Subject: **Pit 10 Backfill Amendment, Appendix 5-2 and Drawing 5-26, Alton Coal Development, LLC, Coal Hollow Mine, C/025/0005**

Title: Revised Drawing 5-26 & Appendix 5-2

**SEDIMENT IMPOUND WATERSHEDS**

COAL HOLLOW PROJECT  
ALTON, UTAH

DRAWING: 5-26

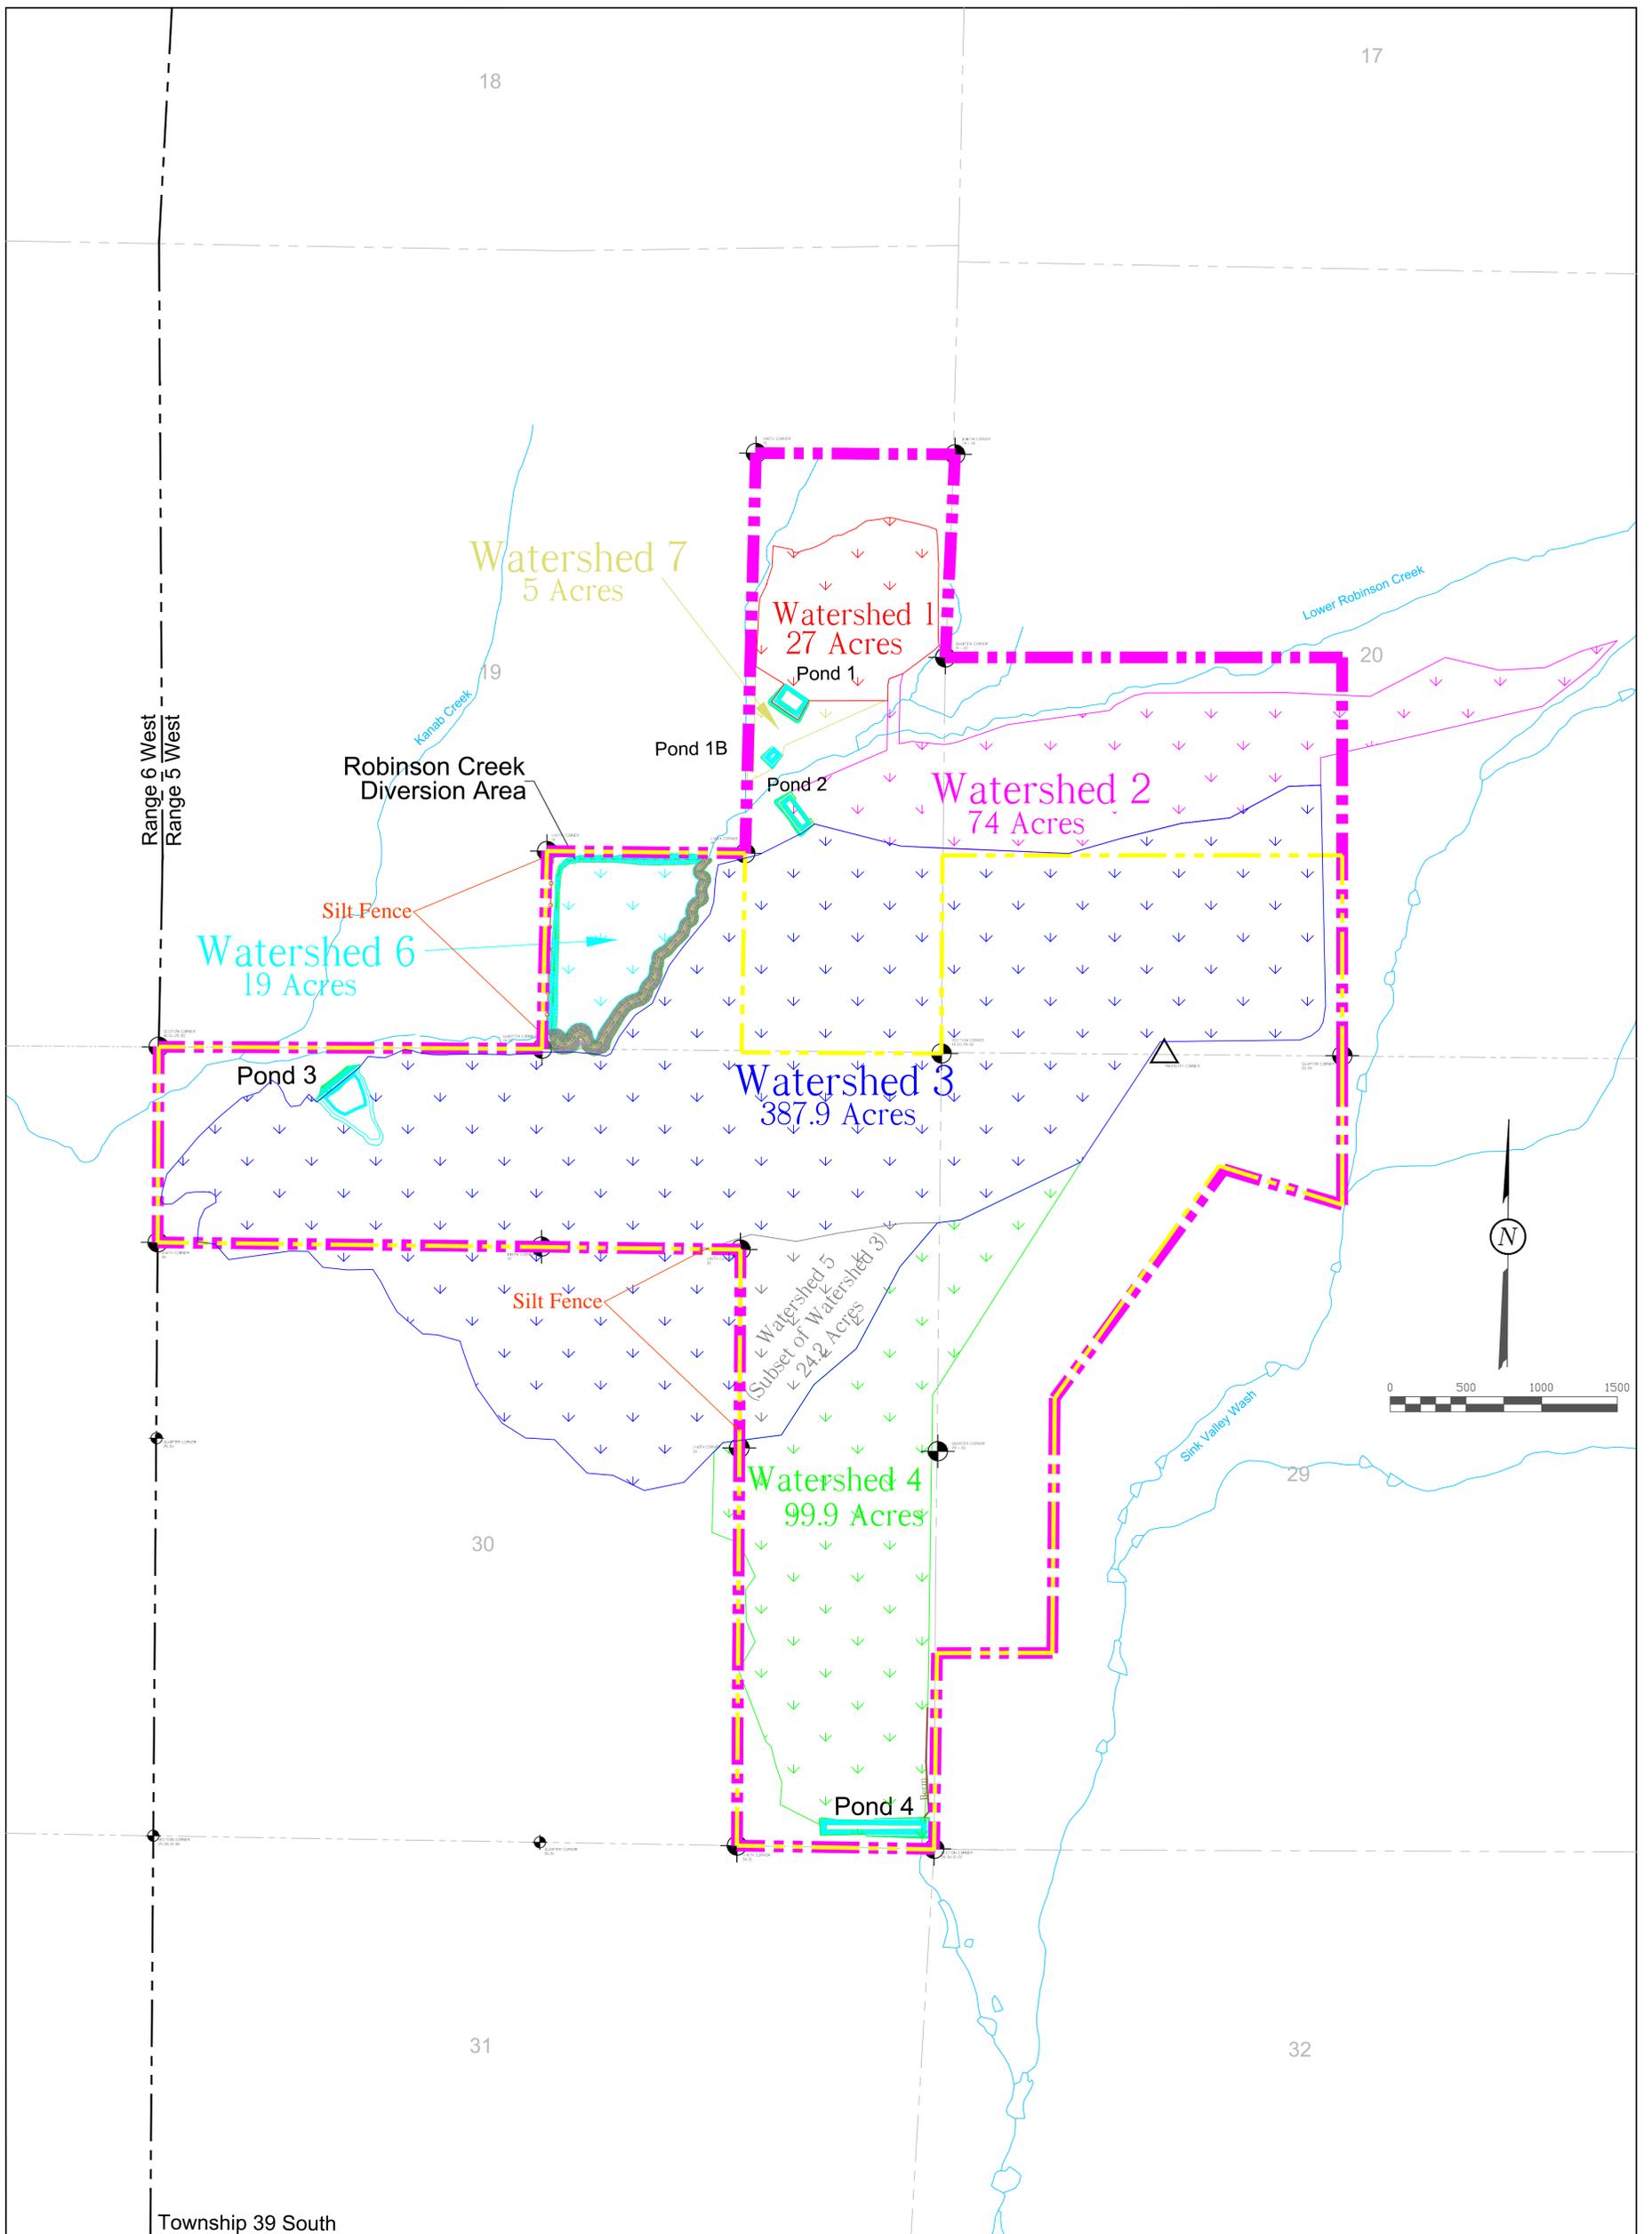
In response to NOV 21163, 21164 and request for inclusion of cross section and plan view drawings for the haulroad to the underground, Alton Coal Development, LLC,(ACD) has uploaded the amended MRP text and Drawings for review by the Division. In addition Appendix 5-2 and Drawing 5-26 have been revised.

Upon completion of the underground mining, the portals will be sealed and the pit will be backfilled. Since it is expected that there will be a deficit of backfill material for this final pit, borrow material will be extracted from a total area of approximately 66.1 acres encompassing the current long term spoil pile and the hillsides directly adjacent to pond 3 to the northeast and southwest. Removing these hillsides will result in additional disturbance (and watershed area) of 30.9 acres. Removal of the borrow material will also result in the re-establishment of pre-mining drainage paths that will increase the watershed for Sediment Pond 3 by an additional 72 acres of undisturbed ground located outside of the permit boundary, as shown on Drawings 5-19, 5-26 and 5-37. Runoff from the additional area of 102.9 acres for a Watershed 3 total of 387.9 acres will all flow to Pond 3. Calculations show that an additional 4.1 acre feet of runoff is expected from this area for the 100 year – 24 hour storm. Since the mining will be completed at this time, the additional capacity presently required for the possible mine water discharge will no longer be required; therefore, the additional 4.1 ac. ft. for the extra area has been added to the required 6.3 ac. ft. for Pond 3, resulting in a required size of 10.4 ac. ft. for the post-mining pond, as shown in the previous table "Sediment Impoundment Capacities". The runoff details and calculations for the additional 103 acre area is shown as "3 PM" in the following tables.

Due to the isolated characteristics and the inability to effectively divert water from Watershed 5 and 6, the method of using silt fence or other appropriate control measures for sediment have been chosen and is included on the Drawing 5-26.
